THE PINES OF TODD ACRES SUBDIVISION

APPLICATION NUMBER 25 DATE August 16, 2007

REQUEST Subdivision

DETAIL SITE PLAN

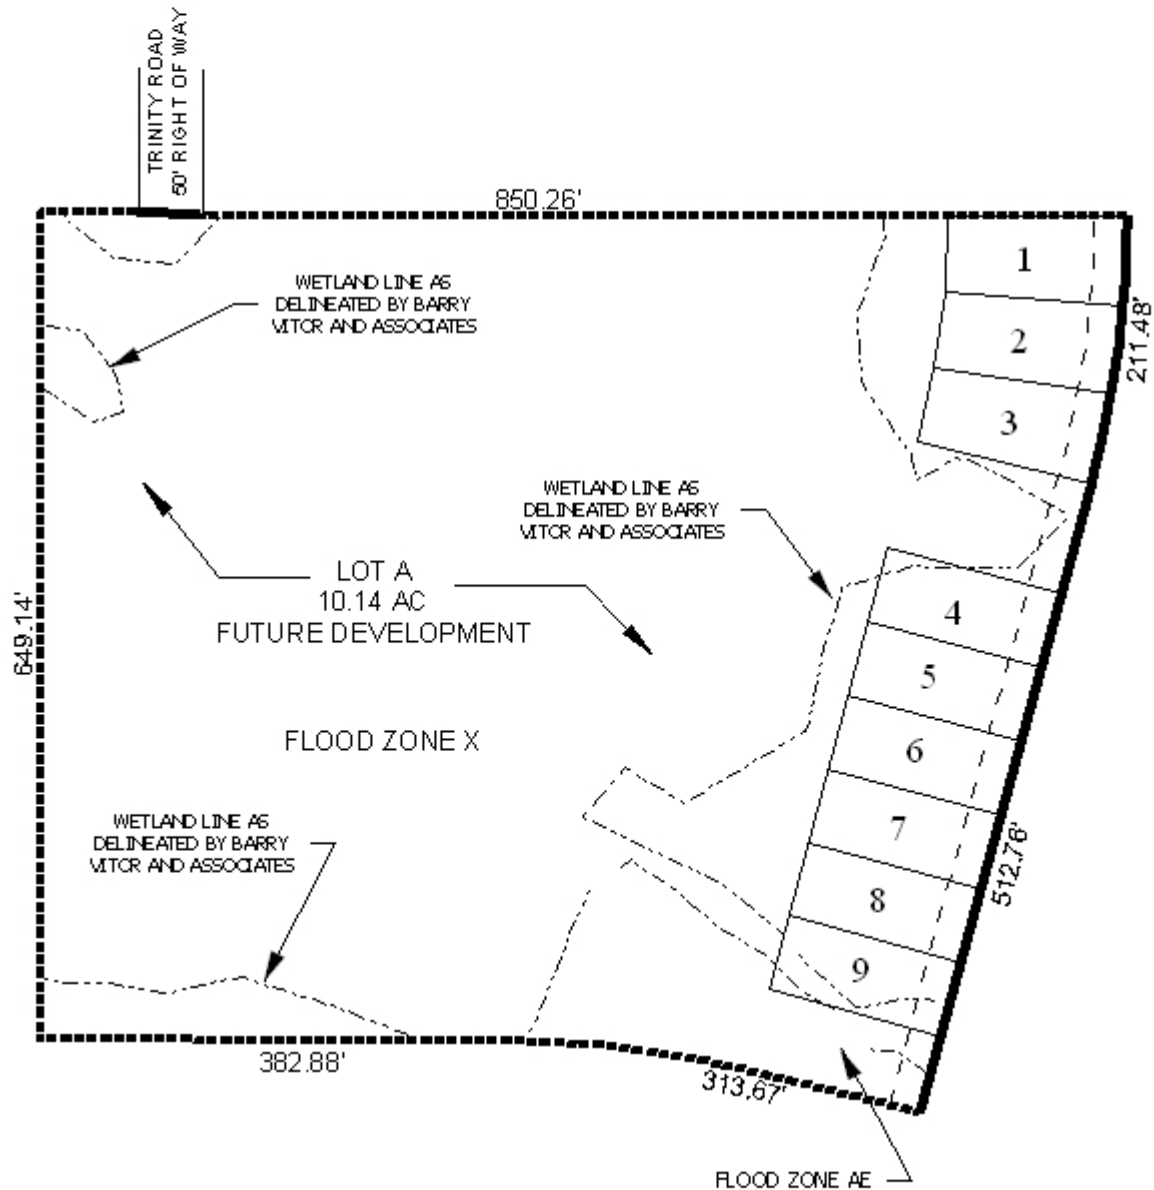
The site fronts onto Todd Acres Drive, a minor street with a 50-foot wide right-of-way. Todd Acres Drive lacks curb and gutter, thus the right-of-way should be a minimum of 60-feet in width. The plat should be revised to dedicate right-of-way sufficient to provide 30-feet, as measured from the centerline of Todd Acres Drive. Furthermore, the 25-foot minimum building setback line should be labeled and revised to reflect the dedication requirements. The site also has frontage on the street-stub for Trinity Road, a minor street lacking curb and gutter. The minimum building setback line should also be depicted from Trinity Road. Proposed Lots 1-9 front Todd Acres Drive with from 60 to 71 feet of frontage; each lot should be limited to one

curb-cut each. Proposed Lot "A", reserved for future development, has two arms which front onto Todd Acres Drive, with the smallest arm approximately 60-feet wide, and the largest approximately 90 feet wide. Lot "A" should be limited to two curb-cuts onto Todd Acres Drive, and one curb-cut onto Trinity Road. The size, design and location of all curb-cuts are to be approved by Traffic Engineering and conform to AASHTO standards.

Wetlands and floodplains are depicted on the preliminary plat, thus the site may be considered environmentally sensitive. Some of the lots appear to be fully encompassed by wetlands, thus the applicant should verify that each lot has 7,200 square feet of buildable area, exclusive of wetlands, or provide evidence of wetlands mitigation approval from the U. S. Army Corps of Engineers prior to the recording of the final plat, if approved. The developer should obtain any necessary federal, state and local approvals prior to the issuance of any permits.

- 1) dedication of right-of-way sufficient to provide 30-feet, as measured from the centerline of Todd Acres Drive;
- 2) placement of a note on the final plat stating that Lots 1-9 are limited to one curb-cut each onto Todd Acres Drive, and that Lot "A" is limited to two curb-cuts onto Todd Acres Drive and one curb-cut onto Trinity Road, with the size, design and location of all curb-cuts to be approved by Traffic Engineering and conform to AASHTO standards;

- 3) revision and labeling of the 25-foot minimum setback line, to reflect the dedication requirements along Todd Acres Drive;
- 4) depiction of the 25-foot minimum setback line from Trinity Road;

- 5) revision of the plat to label each lot with its size in square feet, or provision of a table on the plat depicting the same information;
- 6) provision of evidence that all lots have a minimum of 7,200 square feet of buildable area, or that approval for wetlands mitigation has been obtained, prior to the signing of the final plat; and

- 7) approval of federal, state and local agencies, as necessary due to wetlands and floodplains, prior to the issuance of any permits;
